# Inspection of Automatic Sprinkler System

Automould - ELIDZ - East London

UNC.8484

Photo 5

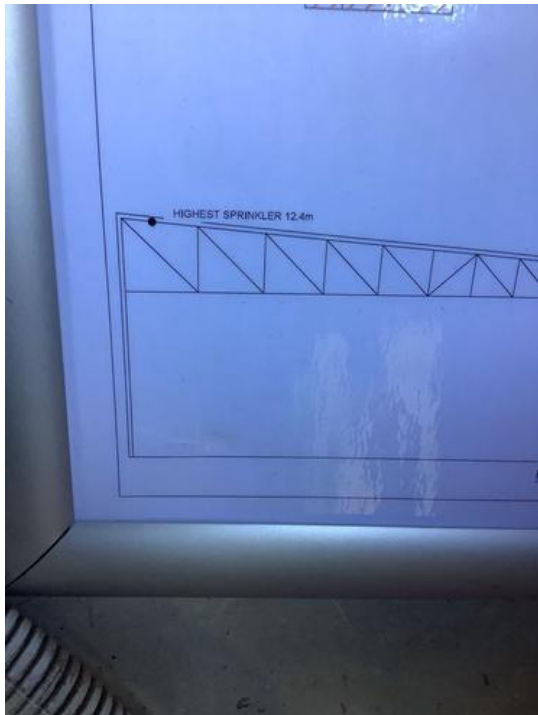
The flow test arrangement is not calibrated to read the flow indicated on the blockplan

The block plan must be updated to include all of the relevant design requirements

The flow test arrangement is not calibrated to read the flow indicated on the blockplan
